CITY OF CARMEL-BY-THE-SEA HISTORIC RESOURCES BOARD

REGULAR MEETING Monday, September 18, 2023

TO:	Historic Resources Board Commissioners
SUBMITTED BY:	Evan Kort, Associate Planner
SUBJECT:	DR 23-130 (Fourtane Jewelers): Consideration of a Track 1 Design Review referral, DR 23-130 (Fourtane Jewelers), for storefront modifications to an existing non-historic building location on Ocean Avenue 3 northwest of Dolores Street in the Central Commercial (CC) District and Downtown Conservation District (DC) Overlay. APN: 010-139-004-000.

Consider Mills Act application 23-146 (Lopez 5 NW, LLC) requesting the Historic Resources Board add a historic resource to the Carmel Register and recommend the City Council enter into a Mills Act Contract with Lopez 5 NW, LLC for the property located on Lopez Avenue 5 northwest of 4th Avenue (APN 010-232-028).

Figure 3. Proposed paint colors.

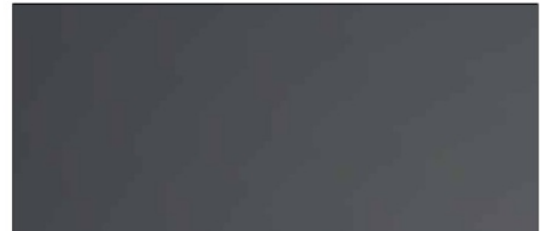
The body color of the building is proposed to be "Slipper Satin" by Farrow and Ball (click here for manufacturer's website). The color is described by the manufacturer as *chalky off white*. The trim throughout is proposed to be "Railing" by the same manufacturer (click here for manufacturer's website). Railing is described by the manufacturer as *a soft black with blue undertones*.

The building color is consistent with the established color palate seen throughout the Conservation District for both historic and non-historic buildings, and is consistent with the Commercial Design Guidelines.

PROPOSED ENTRY PLAN

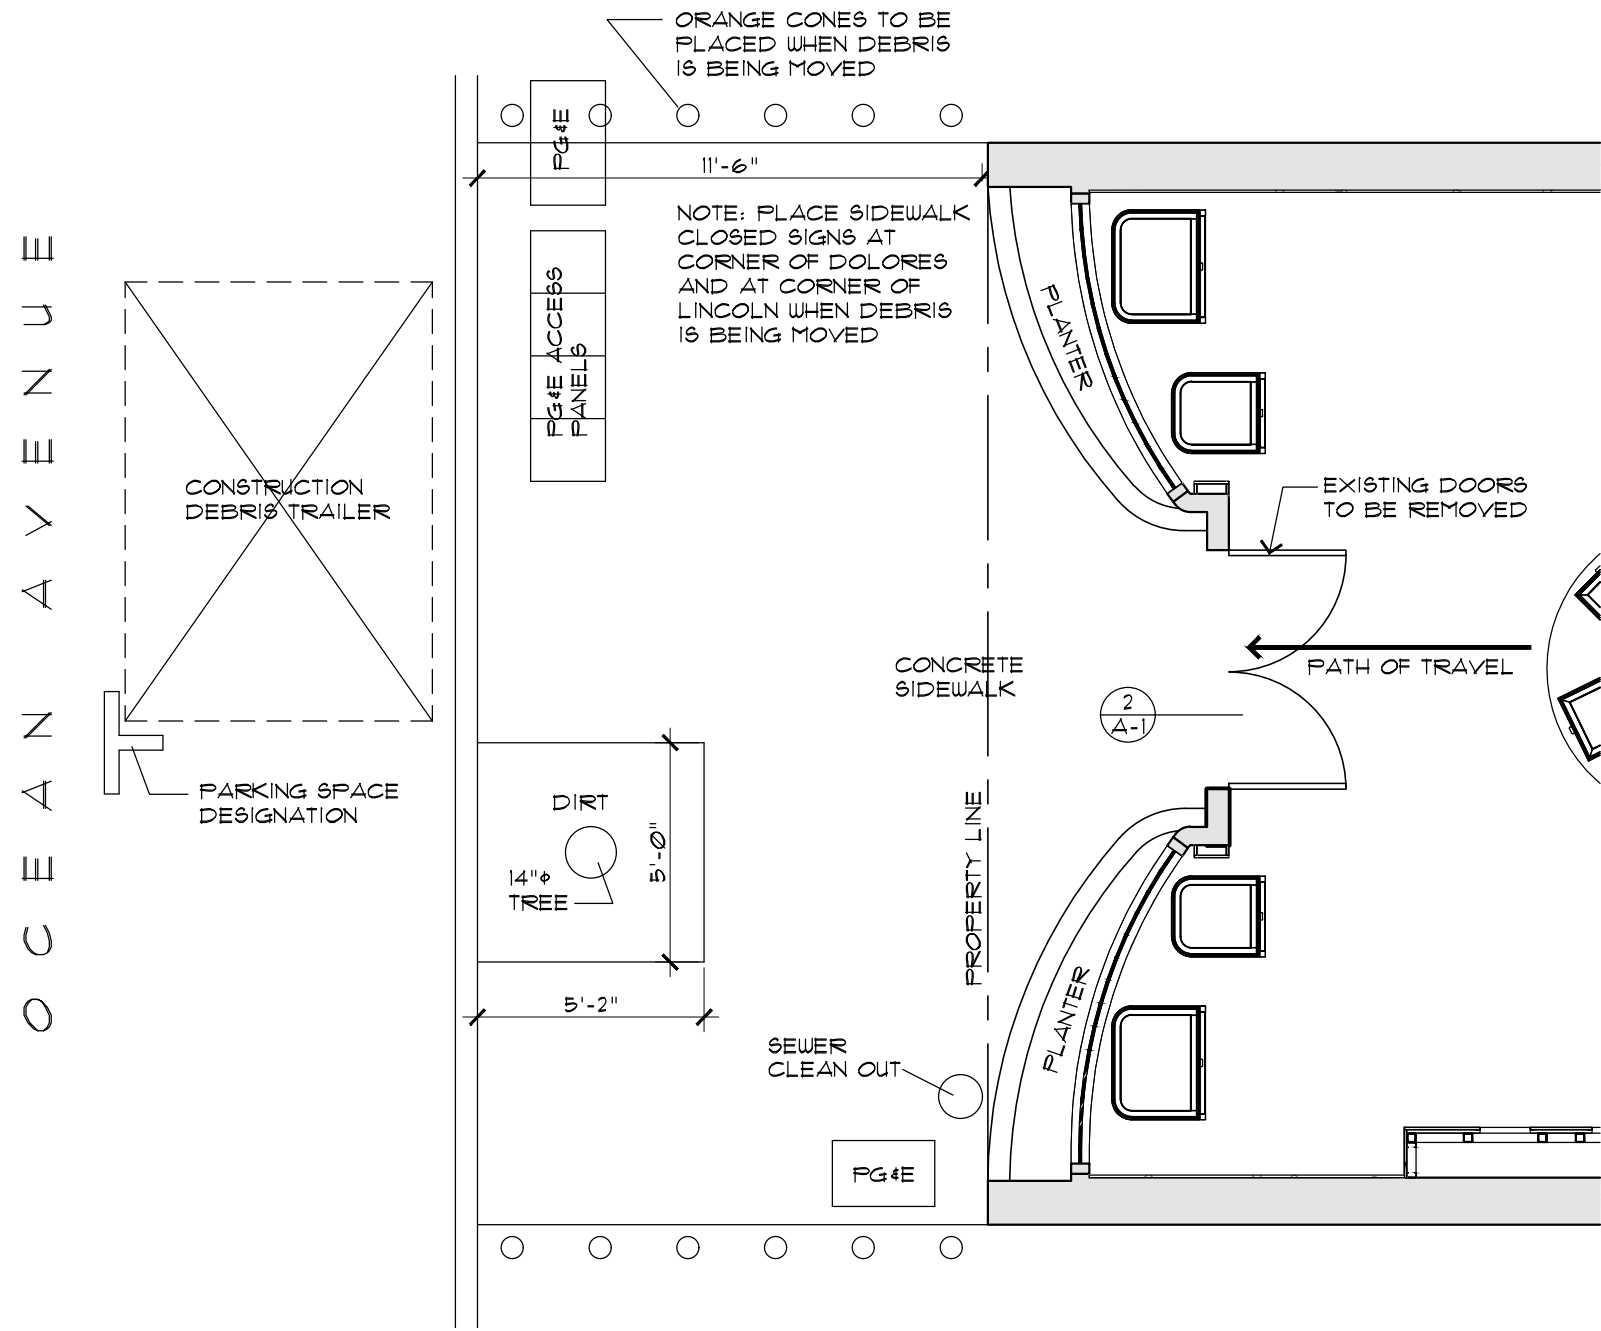
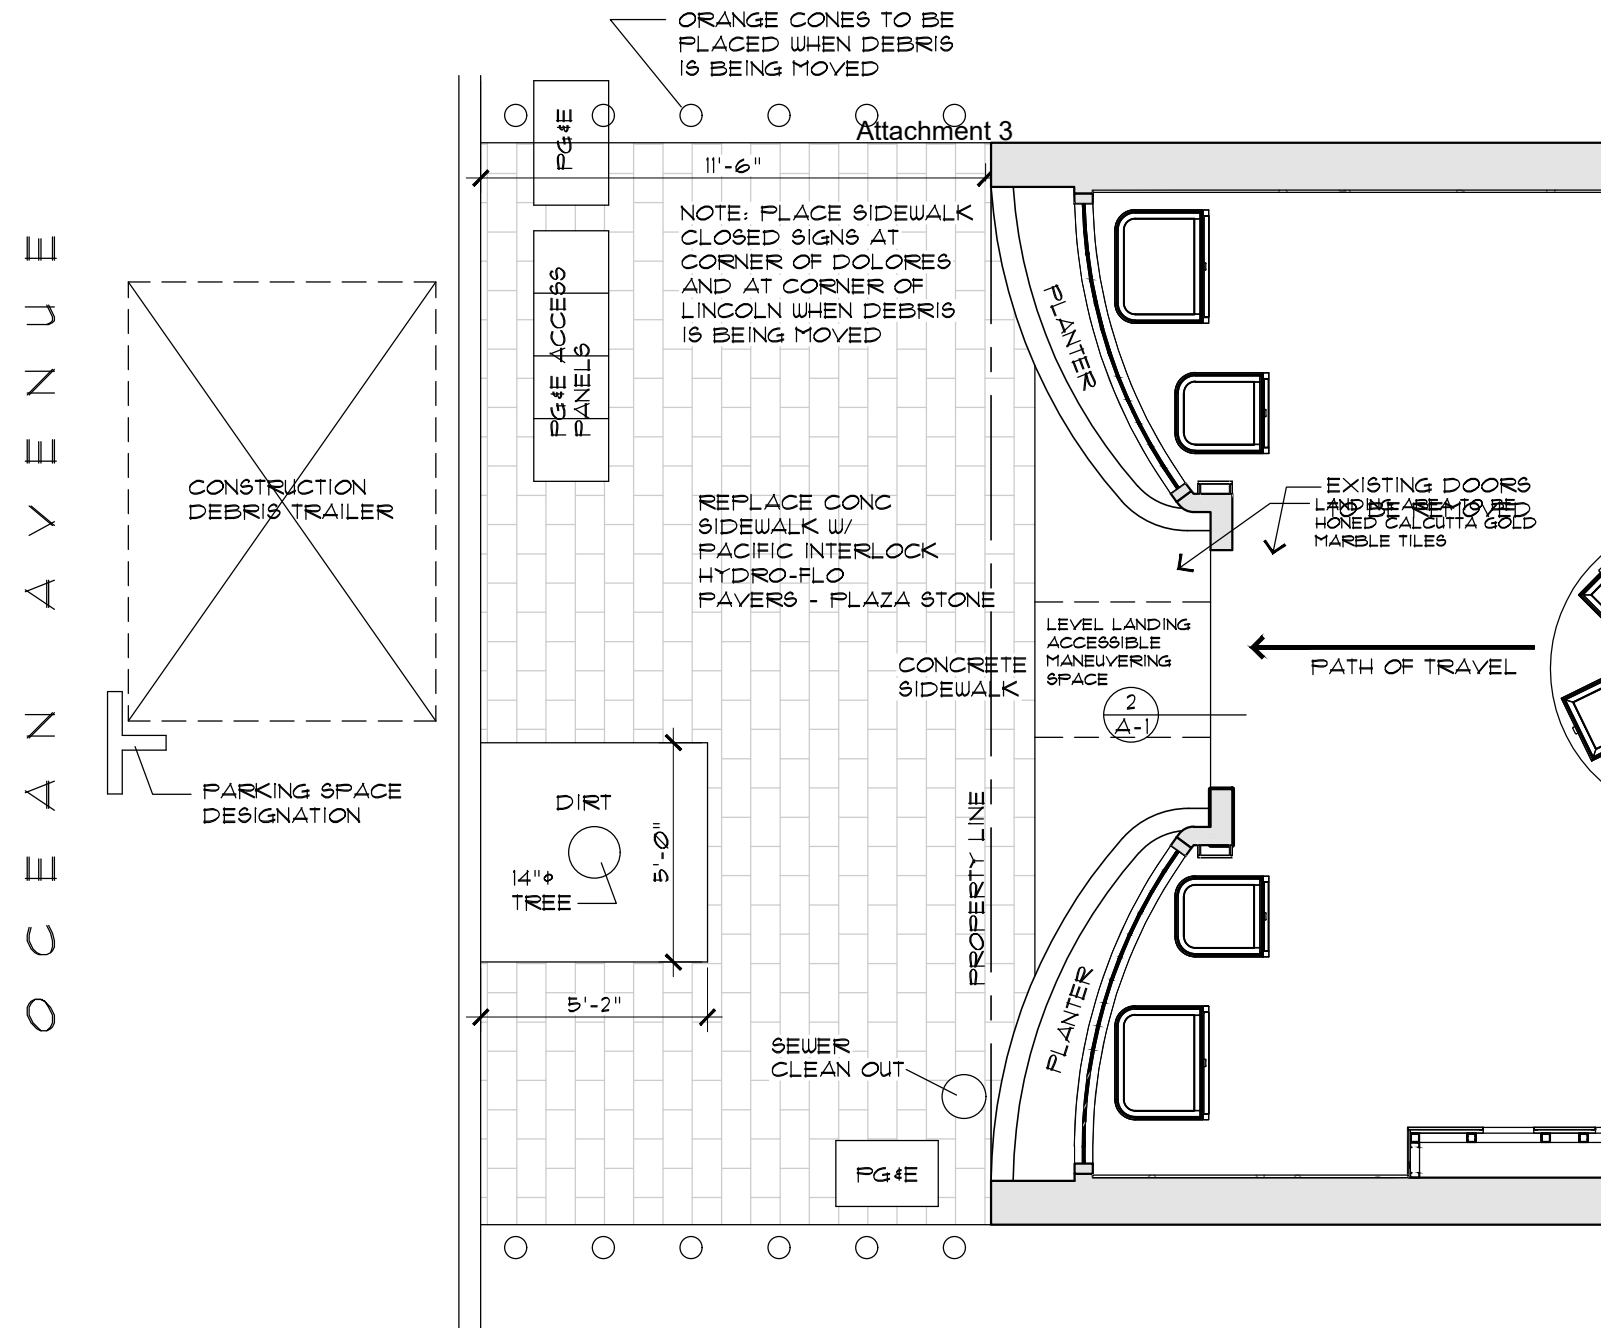
Lastly, the applicant is proposing to replace the public sidewalk adjacent to the storefront with new pacific interlock hydro-flow pavers (click here for manufacture's website). The proposed paver appears to be a deep blue/light black (similar color to the proposed building trim color "Railings"). While staff enthusiastically supports the applicant's willingness to improve the adjacent right-of-way, the proposed paver color conflicts with the direction outlined in the city's Policy Standards for Public Way Design (Policy Standards).

While the Policy Standards state that sidewalks should not appear excessively uniform, and some variety, or break in paving shapes or colors can help in preserving an informal, unplanned visual appearance, materials and colors selected for sidewalks should play a subtle, background role and should not compete with adjacent buildings calling attention to them. The Policy Standards state that sidewalks should *use earthen, warm hues (tan, brown, warm grey). Saturated colors (solid brick red, etc.) and cool hues (green, blue, cold grey) should be avoided.* In staff's opinion, the proposed color is inconsistent with the preferred colors and an alternative should be selected. A condition of Approval has been included requiring an alternative paving material be selected for the right-of-way and the new material will be reviewed for consistency with Policy Standards as part of the subsequent Design Review Approval. Staff is seeking a recommendation from the Board on the paver color before the Director takes action on the Design Review.

RECOMMENDATIONS/DRAFT CONDITIONS	
No.	
1.	Right-of-Way Pavers. Prior to approval of the Design Review application by the Planning Director, the applicant shall work with staff to select an appropriate paver for the right-of-way that is consistent with the City of Carmel-by-the-Sea Policy and Standards for Public Way Design.

Figure 1: Property and right-of-way, viewed from Santa Fe Street.

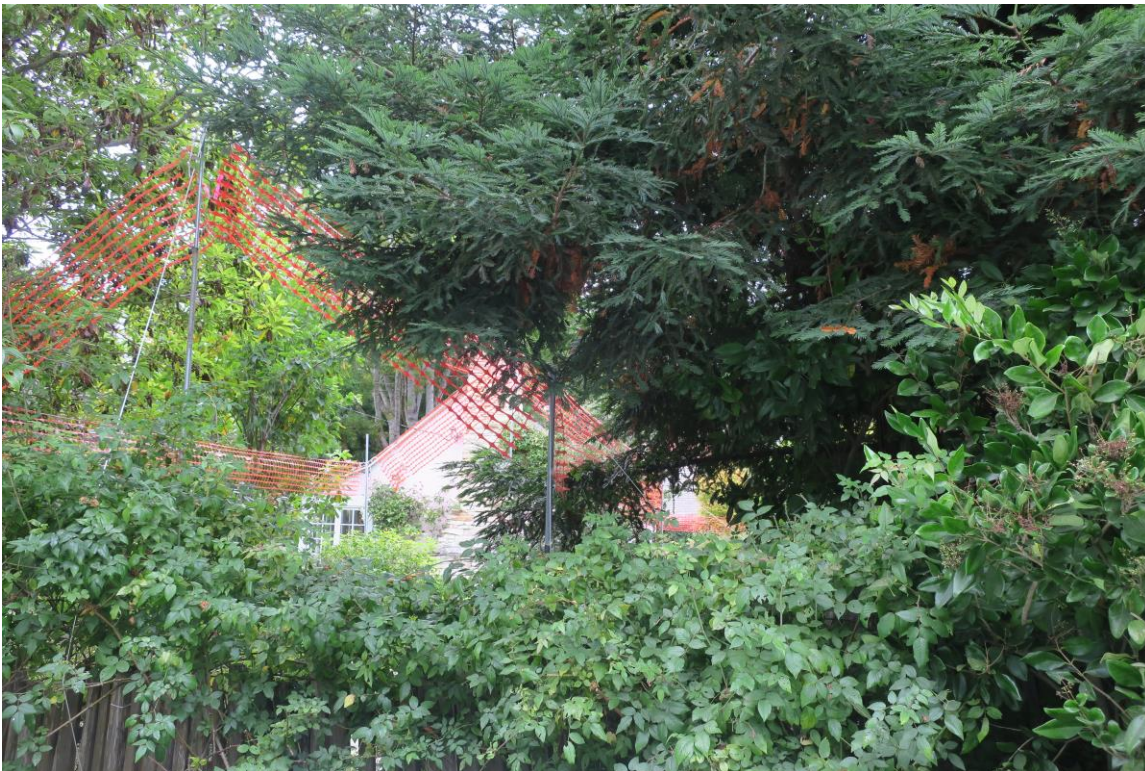
Figure 6: French doors on south elevation proposed to be relocated west (left), with steps demolished and rebuilt to align with the new opening location. Kitchen window with shutters proposed to be relocated east (right).

Figure 7: Bank of three windows proposed to be moved east (left) towards the door, to accommodate the north bedroom addition.
